Inspection Photos

API: 071-08840

Operator: EVERGREEN NATURAL RESOURCES

Inspection Date: 5/24/2021

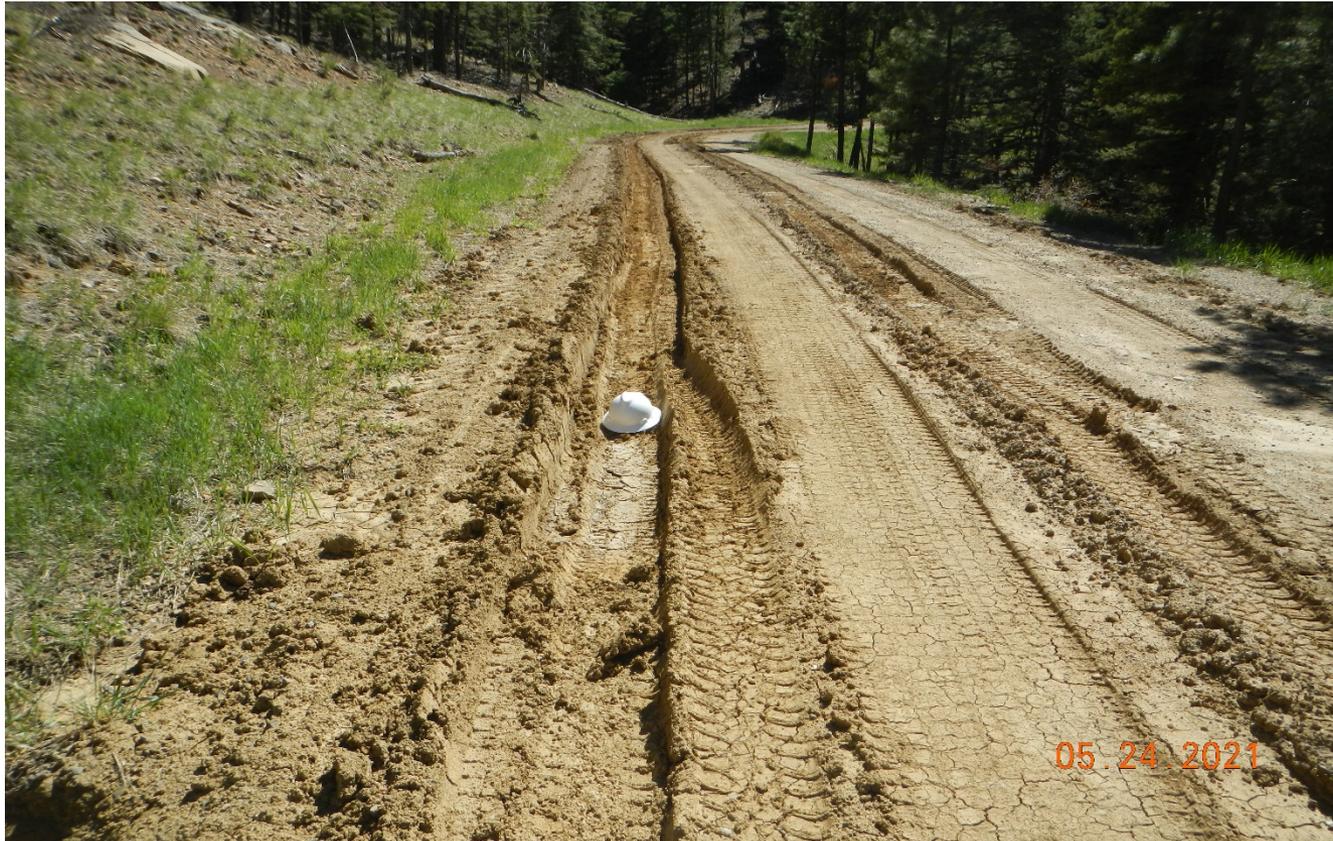
Photo 7. Facing west along the main access road. There are areas along the road that have vehicle rutting and erosion. The road needs to be maintained and stabilized.
